TECHNICAL EVALUATION REPORT
BYRON STATION UNITS 1 AND 2
STATION BLACKOUT EVALUATION

TAC Nos. 68522 and 68523

Final
June 14, 1990

U.S. Nuclear Regulatory Commission
Washington, D.C. 20555

Figure 1 BYRON STATION UNIT 1

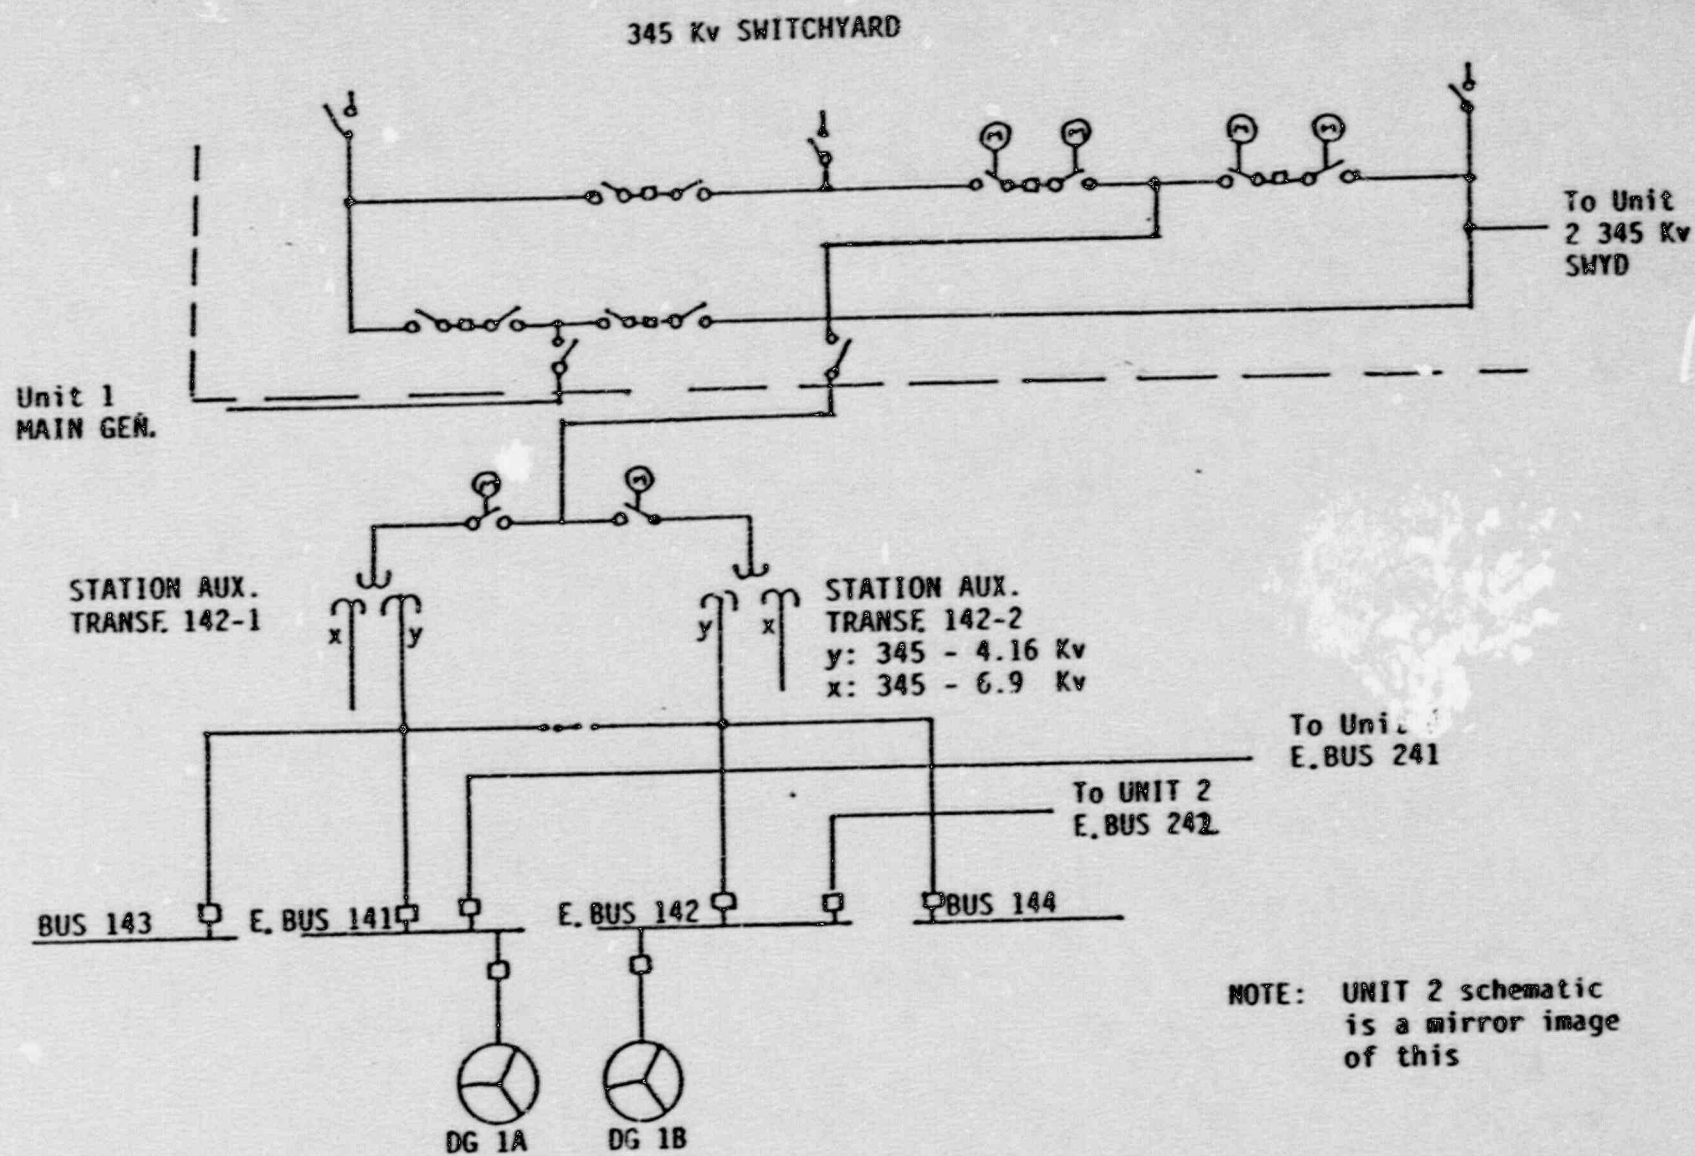
Our review of the Byron Station UFSAR (Section 8.0) indicates that, (see Figure 1):

1. all offsite power sources are connected to the plant through one switchyard,

2. there are two emergency safety feature divisions in each unit, and each division is normally powered from a separate system auxiliary transformer (SAT),
3. the unit SATs (two per unit) are fed through one power line which connects them to the corresponding unit 345 kV ring bus (preferred power source for the emergency buses),
4. each SAT is capable of supplying the design basis accident loads of both divisions of one unit and the safe shutdown loads of both divisions of the other unit simultaneously, and
5. upon loss of preferred power source, all safe shutdown buses can be connected to the alternate power source by a manual transfer.

The alternate power source for each of the emergency buses is from the emergency bus of the opposing unit. The manual line-up requires a total of four circuit breakers (two on each cross-tie) to be closed for establishing power to all emergency buses of the opposing unit. Using the guidance provided in Table 5 of RG 1.155, we conclude that the licensee has correctly established the independence of plant offsite power grouping as "I2."
